Product Change Notification / CAAN-08GYFW165

CCB 5324 Initial Notice: Qualification of MMT as an additional assembly site for selected MIC5219-5.0YMT-TR and MIC5219YMT-TR catalog part numbers (CPN) available in 6L UDFN (2x2x0.6mm) package.

Pre and Post Change Summary

PCN #:CAAN-08GYFW165

LEAD FRAME COMPARISON

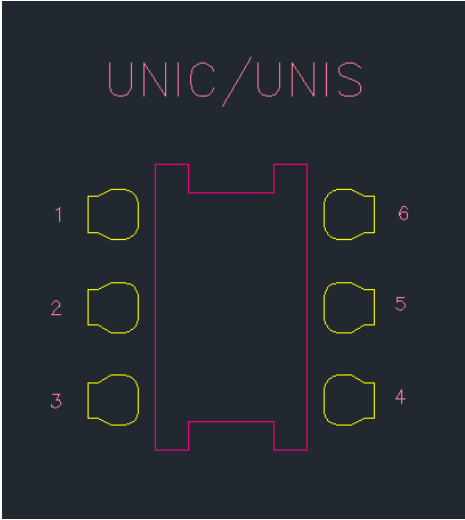
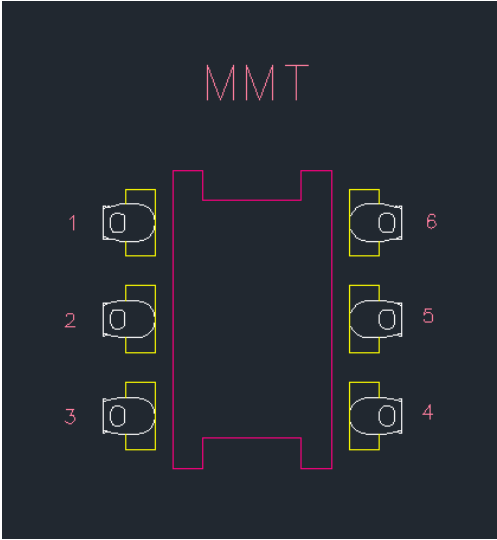
<i>Note: Not to scale</i>			<i>Note: Not to scale</i>	
Assembly Site	UNIC	UNIS	Lead Lock	Yes
Lead Lock	No	No	Lead Plating	NiPdAu
Lead Plating	NiPdAu	NiPdAu	Lead-Frame Paddle Size	63 x 42 mils
Lead-Frame Paddle Size	67 x 42 mils	63 x 42 mils

Note: The lead lock hole fills with mold compound during the assembly process and provides improved protection against moisture penetration around the interface edges between pins and mold compound.
